HEARING REPORT – VOLUME ONE
NOTICE OF REQUIREMENT
372 GLENBROOK BEACH ROAD, GLENBROOK
WATERCARE SERVICES LIMITED

Reporting on a proposed Notice of Requirement to designate land at 372 Glenbrook Beach Road to enable the construction, operation and maintenance of infrastructure for wastewater treatment purposes, including a wastewater treatment plant, and the provision of an odour buffer area around the wastewater treatment plant.

**Notice of Requirement under Section 168
of the RMA by Watercare Services
Limited for the Southwest Wastewater
Treatment Plant**

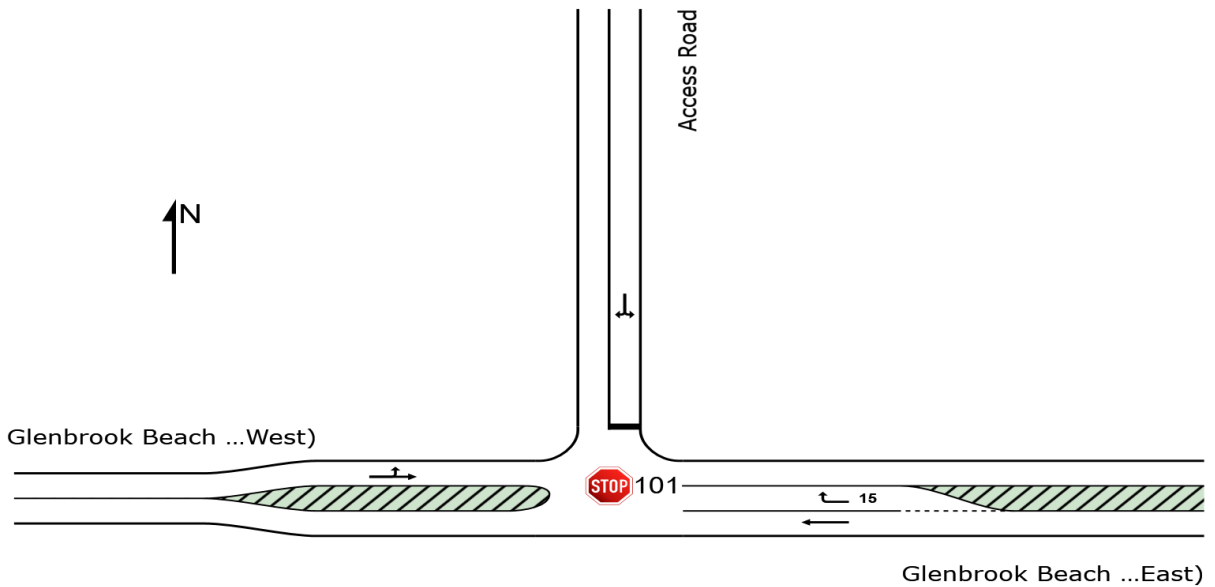
16	Acoustics	Please show the critical 454m setback distance on an aerial map (e.g. a hypothetical 3600 circle originating from the Acoustic Centre) based on a total noise budget of 113 dB LWA.	To identify the extent of surrounding land which is predicted to be exposed to noise exceeding the permitted night time noise level of 45 dB LAeq	Refer to Figure 2 in our report Rp 002 dated 31 Aug 2023. This is shown as an orange dotted line.

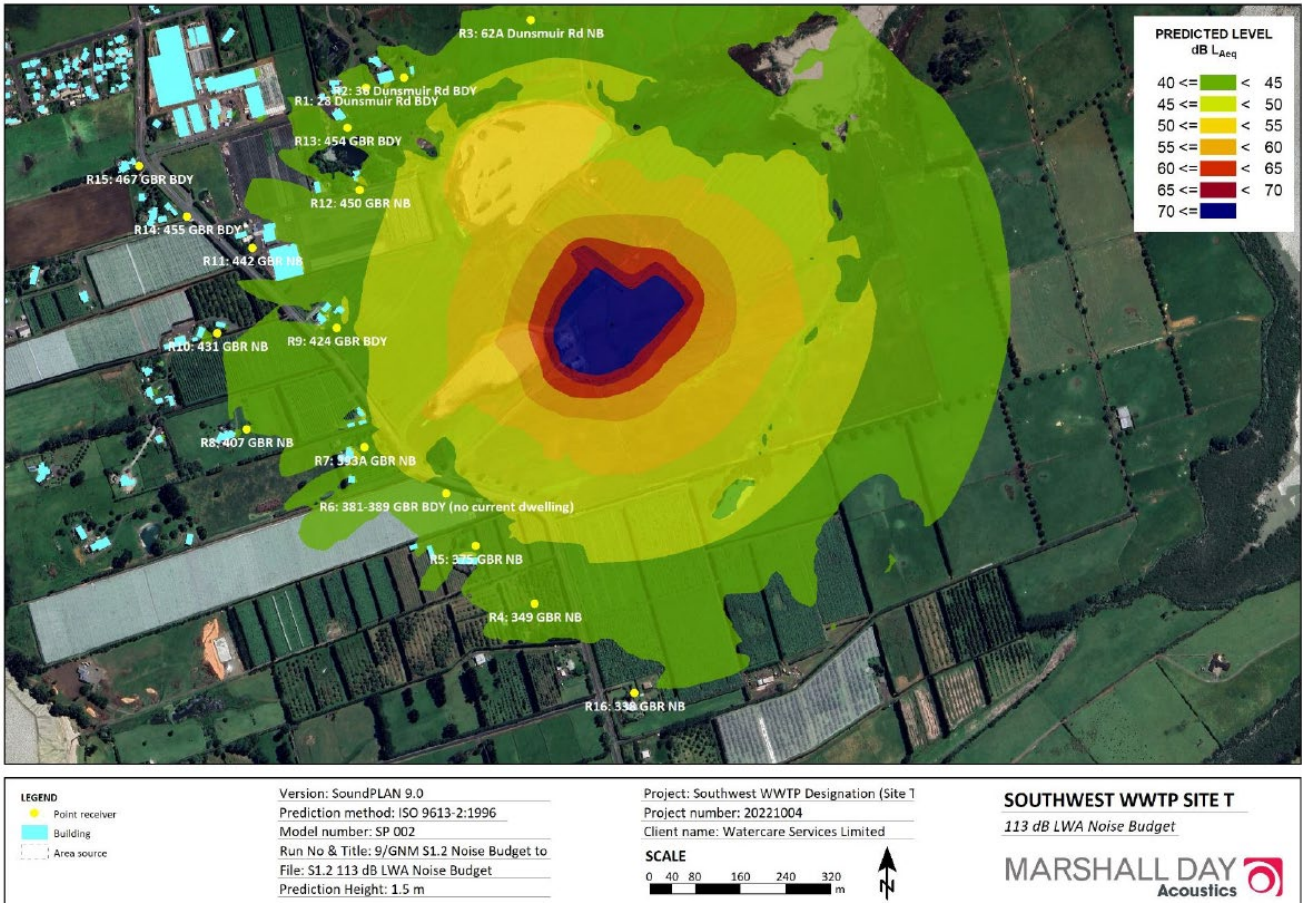
As the individual plant and equipment has not been finalised, MDAs prediction methodology involves reverse calculations from compliant noise levels (e.g. 45 dB L_{Aeq}) at the nearest receiver sites. An industrial noise spectrum has been assumed.

Further, as noise will be emitted by various point sources over the entire treatment plant area, MDA have adopted an 'acoustic centre' which refers to a point located in the middle of the treatment plant from which noise is emitted. MDA have assumed all significant noise sources are outside the 200m boundary setback shown in Appendix B.

By reverse calculation, a noise budget approach has been adopted based on the indicative sound power levels set out in Table 9. I confirm the noise budget of 113 dB L_{WA} is designed to enable compliance when assessed at all notional boundaries and the potential future notional boundary at 381-389 Glenbrook Road.

Figure 1 - Option 1 Access Location with Visibility Splay (extracted from TR Figure 6-5)

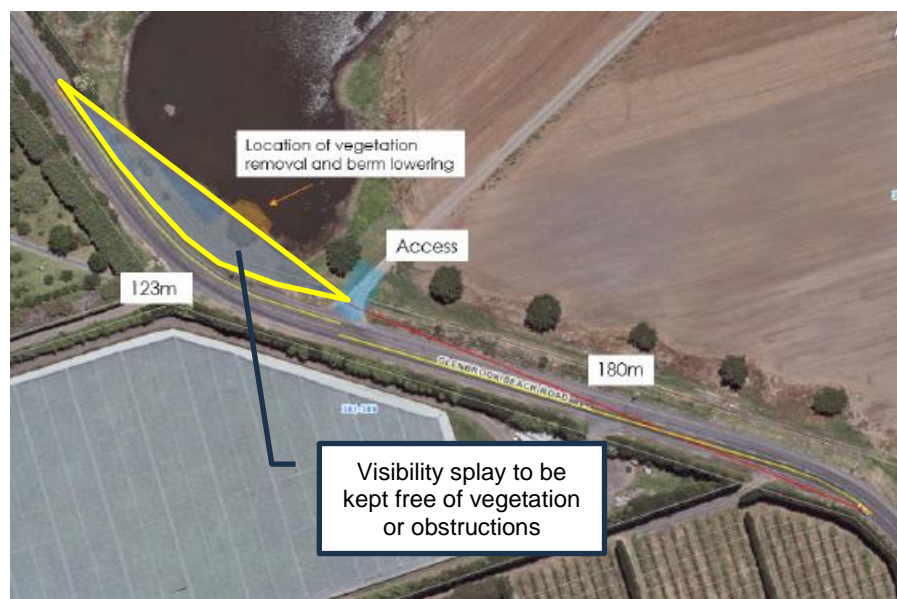
- 3.34 The possible site access locations have been reviewed on site.
- 3.35 It is concurred that Option 2 provides improved sight distances compared to Option 1 and requires less mitigation to achieve the sight lines.
- 3.36 The mitigation for Option 1 (as highlighted in TR Figure 6-5) requires the sight lines to extend across the property boundary and that this would need to be kept clear of vegetation as highlighted in Figure 1. Should this option be chosen, I note that the need to keep the visibility splay clear of vegetation or other obstructions may limit the ability to provide screening of the site from Glenbrook Beach Road.

- 3.37 For Option 2, the area that would need to be kept free of vegetation is entirely within the road reserve.
- 3.38 The TR recommends a right turn bay be provided. I concur that a right turn bay is appropriate, particularly for construction, as motorists travelling northbound on Glenbrook Beach Road would have restricted visibility to a vehicle waiting to turn right from the existing northbound traffic lane, particularly for the location at Option 2. Furthermore, the right turn bay would mean that right turning vehicles would not impede the flow of northbound traffic. I consider that the right turn bay is required for both the safe and efficient operation of the site access.
